Renal Medicine Assoc. Clinic, Journal Center, Phase 2, ZAP D-17

Re: Renal Medical Associates Clinic Drainage Management Plan and Conceptual Grading Plan

Renal Medical Associates Conceptual Grading and Drainage Plan Resubmittal

Re: Renal Medical Associates Grading and Drainage Plan Engineer's Stamp dated 9-6-11 (D-17/D020)

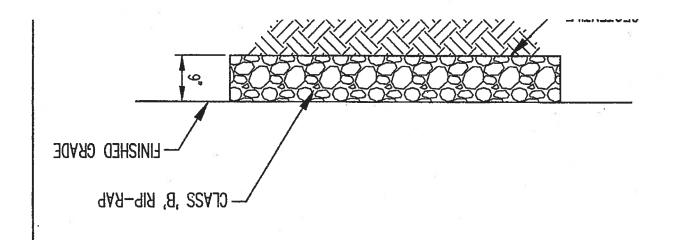
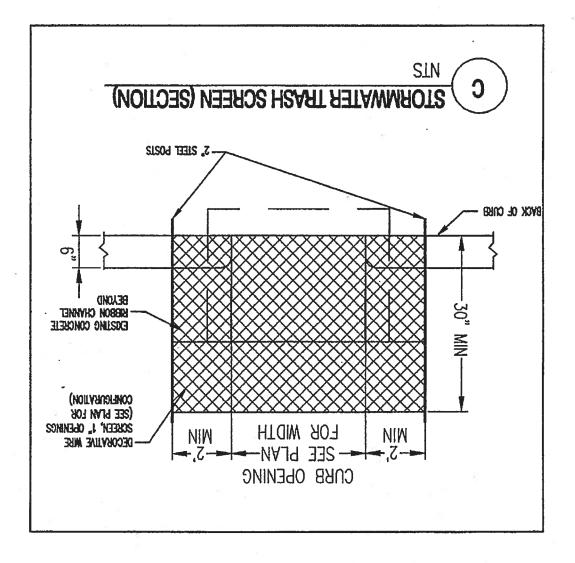
I reviewed the plan and approve the drainage concept. I would like to see a detail of the curb screens that will serve to collect onsite debris. I have attached two details of screens that have been used for commercial developments. The first one is on a rundown to the North Pino Arroyo east of Tiburon St. The height can be lower, and I don't think you will need 2' overlap on the curb for the smaller flow rates from this site. The second one has been used on a couple of developments in Journal Center that flow to the North Pino Arroyo. You don't need the gravel trench in front of the screen. Also, disregard the pond call-out.

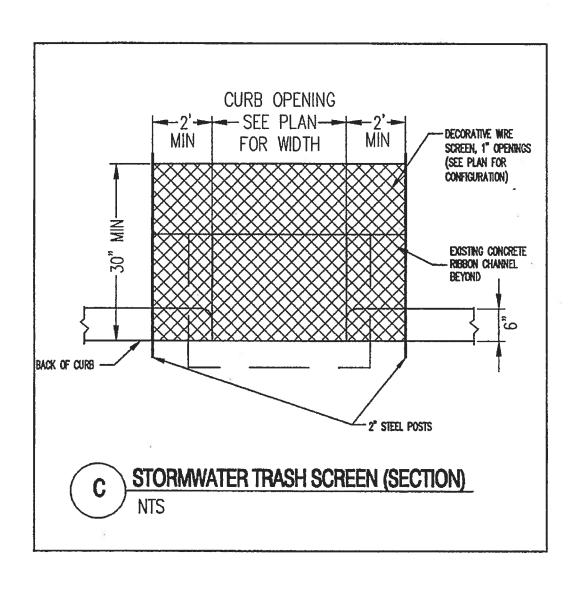
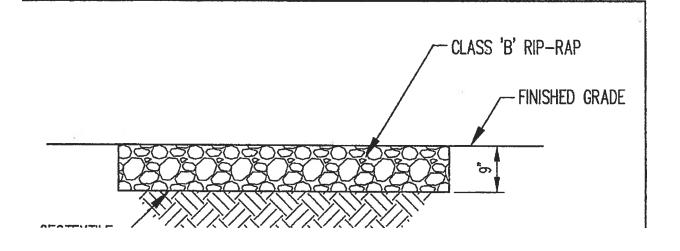
I reviewed the plan and approve the drainage concept. I would like to see a detail of the curb screens that will serve to collect onsite debris. I have attached two details of screens that have been used for commercial developments. The first one is on a rundown to the North Pino Arroyo east of Tiburon St. The height can be lower, and I don't think you will need 2' overlap on the curb for the smaller flow rates from this site. The second one has been used on a couple of developments in Journal Center that flow to the North Pino Arroyo. You don't need the gravel trench in front of the screen. Also, disregard the pond call-out.
